Memo to Mr. A. M. Toye, **Date** November 10, 1960.
Bridge Engineer, **Subject** FOUNDATION INVESTIGATION REPORT
From Materials & Research Section. **By:** Wm. A. Trow & Associates, Inc.

Re: C.N.R. Overhead and Hwy. 403 Underpass
Lemonville Rd., Aldershot, Ont., Dist. 4.
W.P. 197-58.

FOUNDATION INVESTIGATION
HWY. 403, C.N.R. CROSSINGS ON LEXINGTON RD.,
ALDERSHOT, ONTARIO
W.P. 197 - 58

SUBJECT: Twelve Mile Creek Bridge
W.P. 296-65, Site 10-155
Highway 2, District No. 4

RESULTS OF SHORT TERM SLIP CIRCLE STABILITY ANALYSIS
 PROPOSED CUTTING HIGHWAY N^o 403

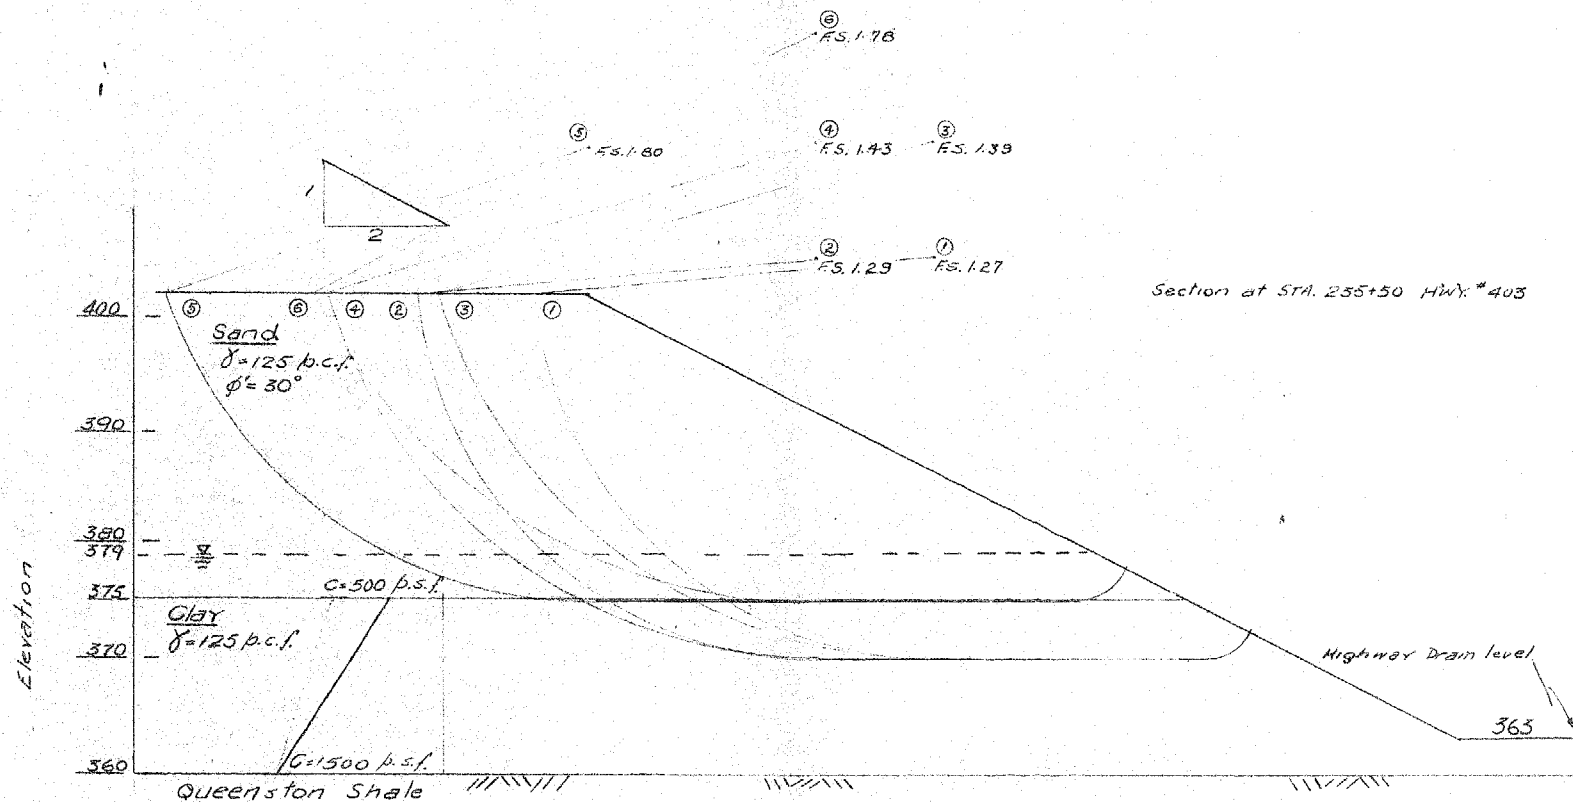
The calculation of the stability of the cutting slopes was carried out under the supposition of a certain ground water table. It seems to us that even more unfavourable ground water conditions can occur (after long rainfalls and during the spring thaw season) and a 2-1/4:1 slope, which is similar to the existing natural ground slope, is the logical recommendation.

In order to ensure that the cutting is permanently stable with a factor of safety of 1.3 against failure this north cutting should be made at $2\frac{1}{4}$ to 1. The existing hillside falls approximately at this slope.

HIGHWAY NO 2 & BRONTE CREEK		
PROPOSED SUB - EXCAVATION		
W. P. 296-65	DIST. 4	JOB 67-F-42
DRAWING NO. 67-F-42 B

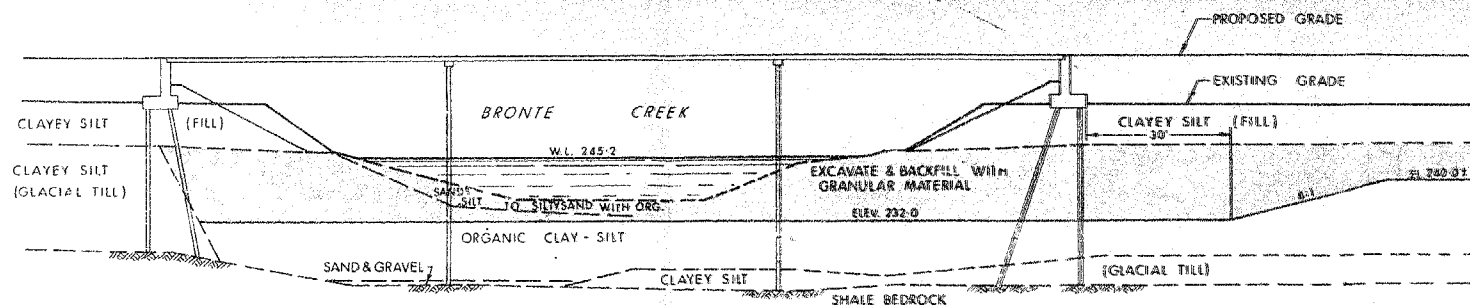
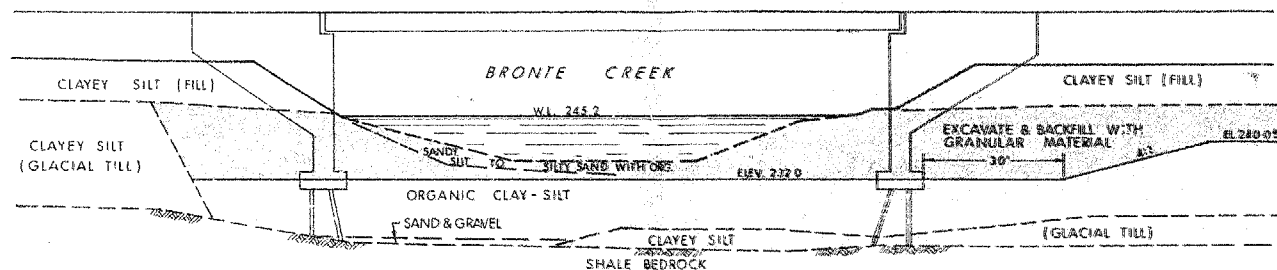
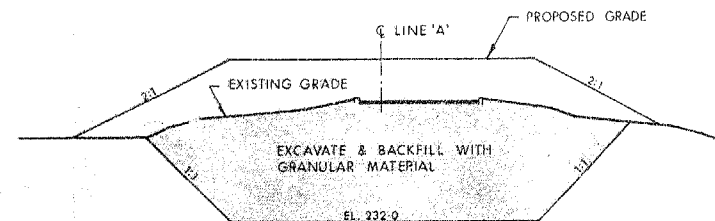
It is noted in this regard, that it is proposed to place granular backfill within the bridge waterway to the limits shown on drawing 67-F-42B of the Foundation Investigation Report. The backfill so placed, would extend between the elevations 232.0 and 236+ in mid-stream and higher near the abutments. These upper limits on the fill extend up to 3'+ above the present stream invert. As such, some obstruction of the present water-way would result. Further, it is doubtful that scouring of the backfill so placed could be controlled.

- (ii) It is thus recommended that the granular backfill within the waterway be omitted, since it cannot be depended upon either to provide stability for the approach embankments or to protect the underlying organic clay silt. Further, as indicated above the backfill placed to the limits indicated in the Foundation Investigation Report would partially obstruct the waterway.

In the case of the single span structure illustrated on Drawing No. 67-F-42B, the rip rap apron should be extended upstream a distance equal to the length of the side walls of the abutment, and should extend laterally to cover the entire length of the abutment pile cap of the upstream abutment walls.

- (iv) In the event that design proceeds according to the 1 span structure illustrated on drawing no. 67-F-42B, it is recommended that both abutments be provided with either cylindrical or box transition sections on the upstream and downstream sides. It is anticipated that the construction of the abutments for this alternative could be carried out within cofferdams which would be left in place after completion to protect the foundations and end sections of the approach embankments. In such a case, the box abutments as detailed on drawing 67-F-42B are acceptable. Further, with the cofferdam left in place, it would not be necessary to deliberately limit scoured depth for hydraulic reasons. Hence the rip-rap apron discussed above could be eliminated unless required by structural limitations of the cofferdam as left in place.

If scoured depths in excess of 15'-6" are unacceptable from the point of view of abutment and approach embankment design for the 3 span alternative of drawing no. 67-F-42B, it is recommended that sheet piling be provided to limit the lateral extent of scoured waterway. The height, location, type and tie-back details for such piling will depend upon structural limitations, and as such will dictate the selection of permissible scoured depth and hence width of the waterway provided for this alternative. Again, the requirement for the rip-rap apron depends primarily upon structural capabilities of the piling. If it is not required to deliberately limit scoured depth from this point of view, the apron may be omitted in this case as well.
